5.0 Design Development

5.5 - Discussion with Camden Council Design Officer 21.02.2011

5.6 - Presentation to the Greater London Authority 24.02.2011

5.7 - Discussion with Design Officers from Camden Council and the GLA - 08.03.2011

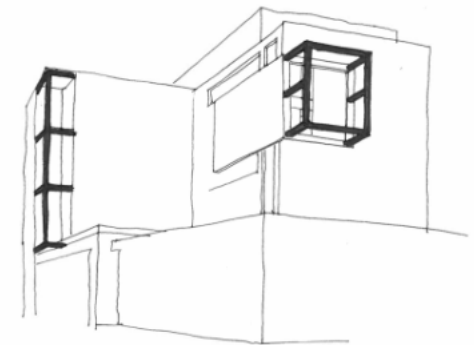
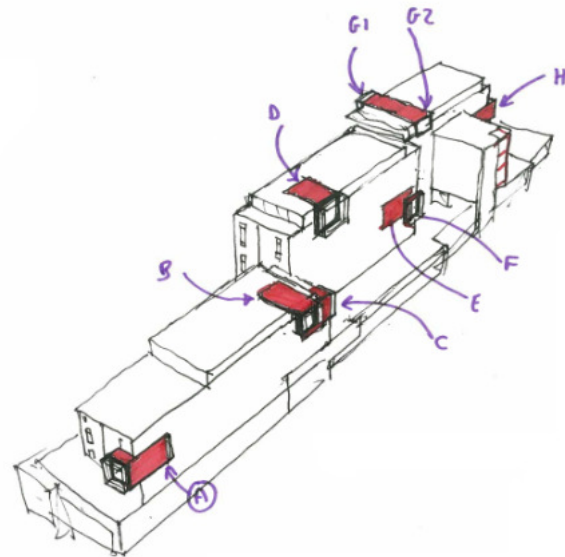
The sketch on the opposite page was sent by the design officer. It shows two elements of the design that he wanted us to explore. Firstly, slots in the brickwork should be more pronounced. This can be achieved by making the reveals deep, and by placing more brick around them, ie fewer slots, more brick. This is something that we explore later and indeed has found its way into the final design.

The second element of his sketch is the projecting boxes. The suggestion is to project the boxes in two directions.

This main focus of this discussion was on the expression of the boxes. The Design Officer was keen to see significant projections of the boxes to be at least 1.5m, in order to strengthen their purpose. It was agreed that we would discuss further with the client, to see if there is a way we can improve on the sketches tabled here.

The other issue regarding the depth and frequency of the cut outs was also discussed. Design Officer sought a 400mm deep reveal and to reduce the amount of cut outs to really accentuate them. We agreed to pursue this line of thought.

We discussed this with our clients in terms of the buildability but we also tested it against our original concepts. We felt that the boxes should be seen to be sliding into place inline with the modules and by projecting out in two directions at the corners, they would look as though they were sliding in from an angle. We wanted to explore the leaning out idea, but in a more directional way and in a way where we could express this idea in several locations.

The sketches shown on this page offer an idea for how to address that. We can, without compromising the modular construction apply a frame to the building. This frame could be left exposed or be clad in louvers, with the same material as the boxes to express movement as if by slotting into place they have left a trail. This mesh would also link the ideas expressed by these 'moving' boxes with the mesh panels forming the fence of the Travis Perkins depot below.

Fig - 5.8.1 - Design Development of the Colour and Materials

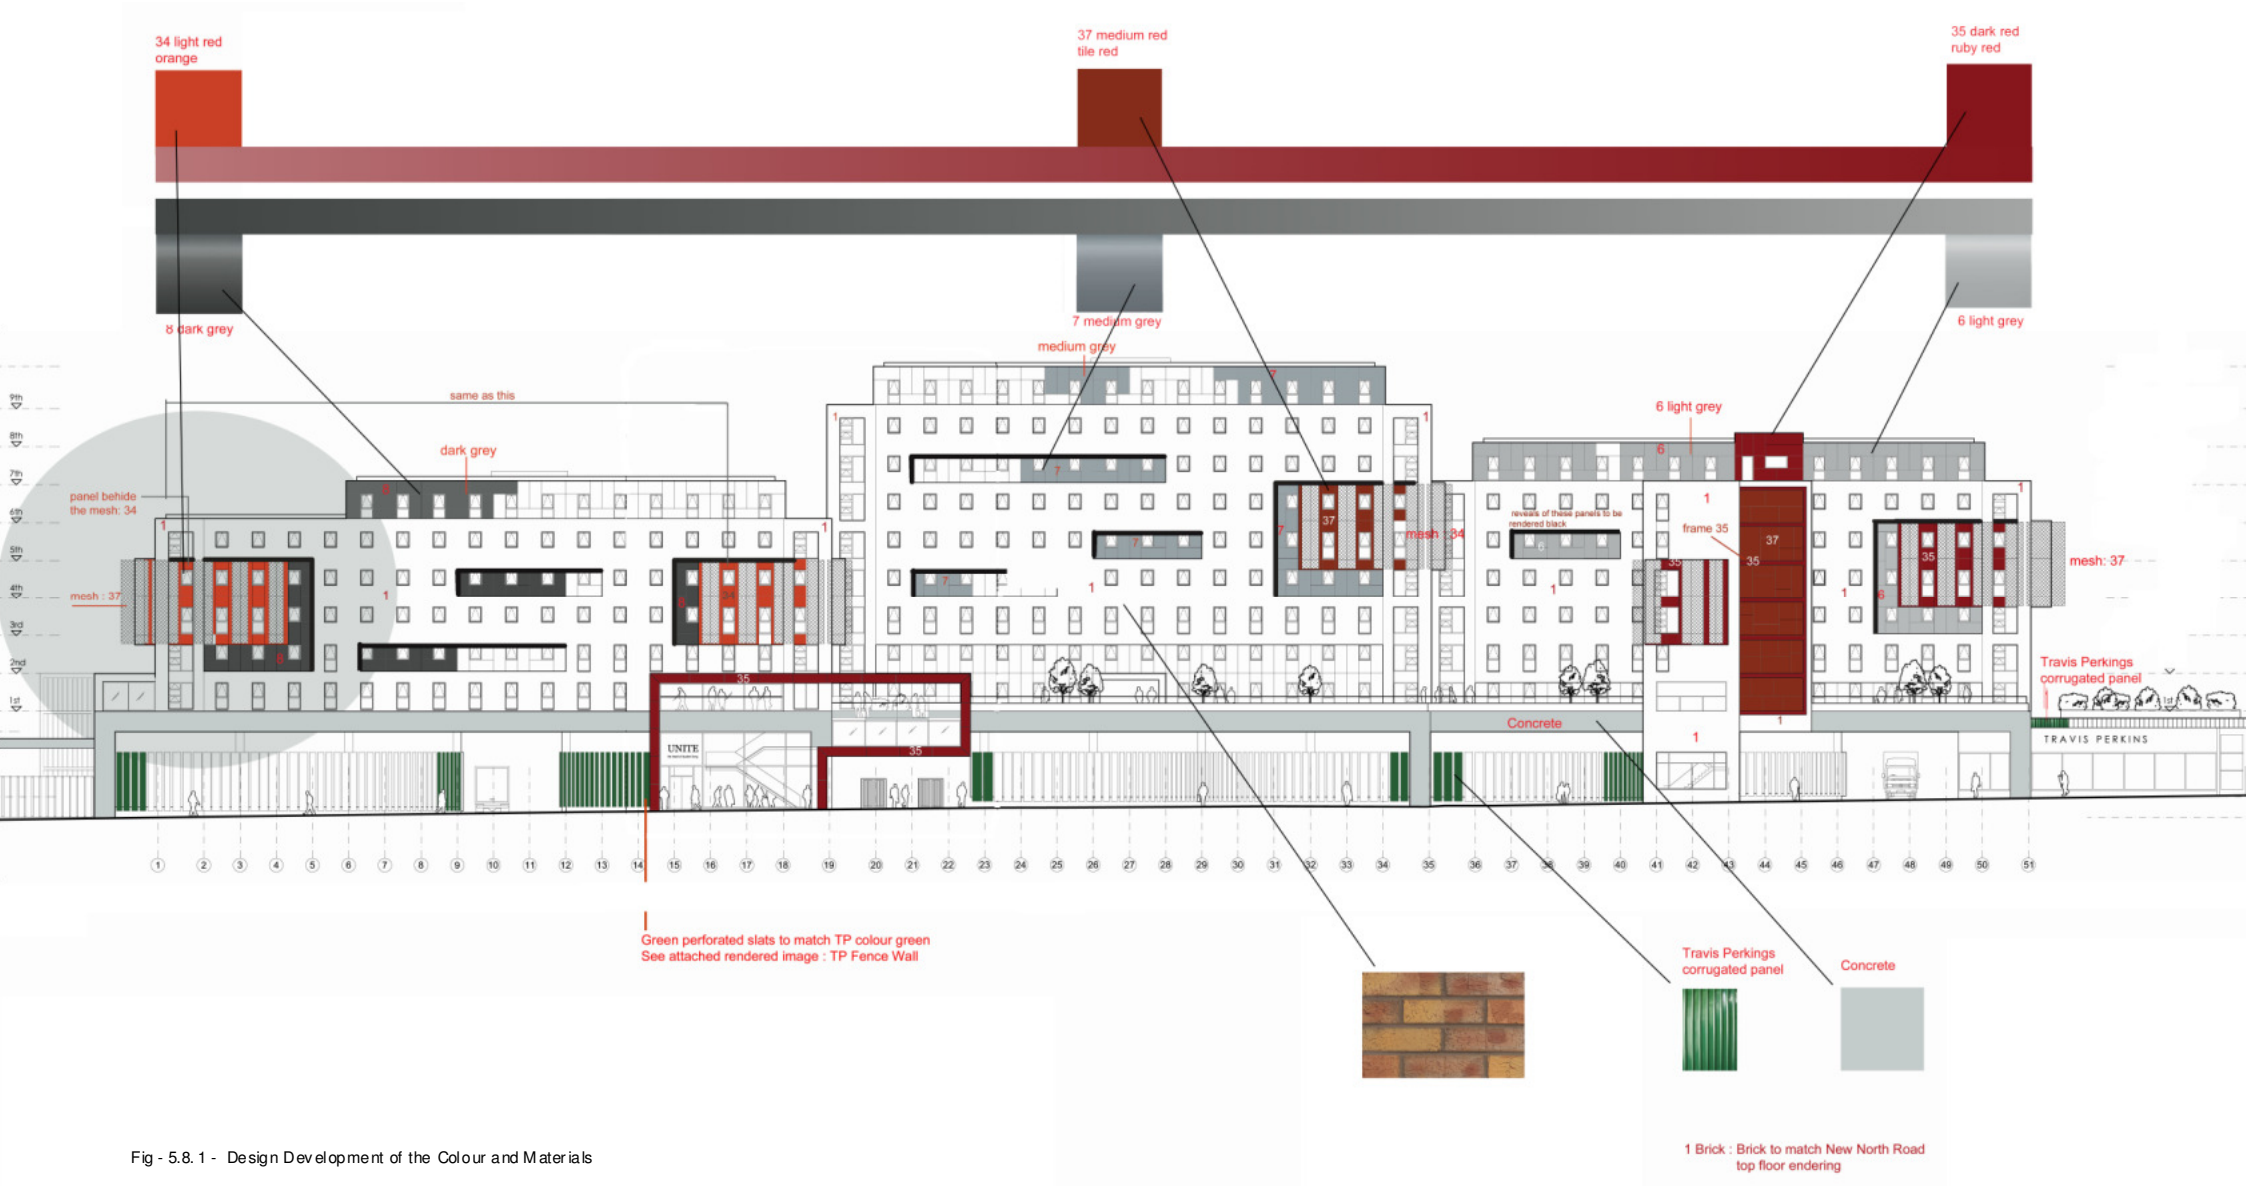
- The red boxes were accepted as elements of interest that added to the overall composition.
- The GLA's design officer was keen to see some more development of the elevation design. He said the long elevation of the building appeared very repetitive and horizontal. It was however accepted that the elevation drawing was misleading as the development is more fragmented than that and needed to be seen in three dimensions. He also suggested we look again at larger windows in the rooms, such as floor to ceiling windows, and also at varying the colours across the site to give each block its own identity.

- We looked at introducing a different materials palette for each block. However, we have always wanted the development to look cohesive, not a collection of disparate blocks. This has been fundamental to our design ethos since the start. However we are now proposing to introduce a gradation of colour across the site from dark red on light grey at the North, to light red on dark grey to the South, with a multi stock brick tying everything together. (fig 5.8.1)

Fig - 5.8.3 - Study of the Effect of Separating the Blocks

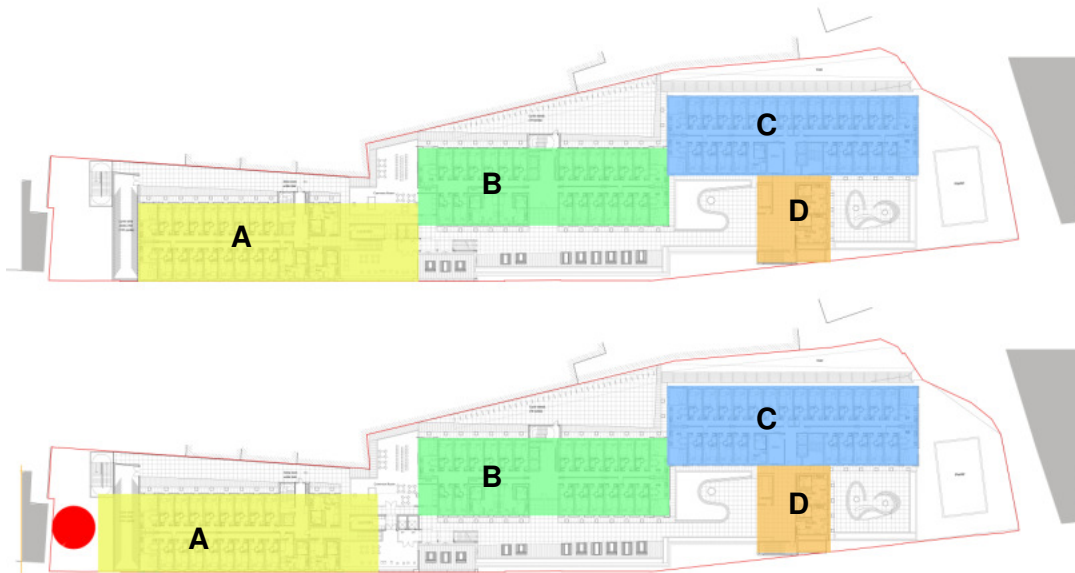
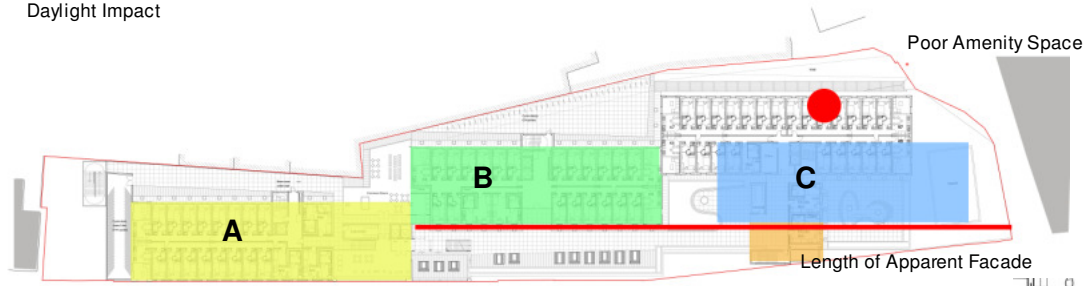
- To separate one of the blocks from the other two by 10-15metres.
- Vary the treatment of the three blocks with less emphasis on the continued horizontal treatment.
- Varying and increasing the size of windows on all elevations, including the ends of the blocks, trying to emphasise a depth to the building.
- Providing more information on the maintenance, weathering and colouring of the proposed materials across the whole building and amenity space
- We should provide detailed information on the access and detailed design of the North amenity space.

- The diagram opposite (fig 5.8.3) shows the impact of introducing a separation space between the blocks. Moving Block A would impact excessively on the daylight of St Mungo's, which is why we've always kept a space between the development and the neighbour. Moving Block C would mean the block has to come forward on the site, thereby making the buildings, from certain angles, look very linear. This would also create a more hidden amenity space in the least attractive part of the site. We were also concerned that the view between the blocks would look unattractive (fig 5.8.4) Block C would also then lean out over the Travis Perkins showroom which has been designed and expressed as a separate element, distinct from the student development. Furthermore, our concept has always been about connections and communication, and not separation. For these reasons, we decided that the current format of the blocks on the site is the correct one.
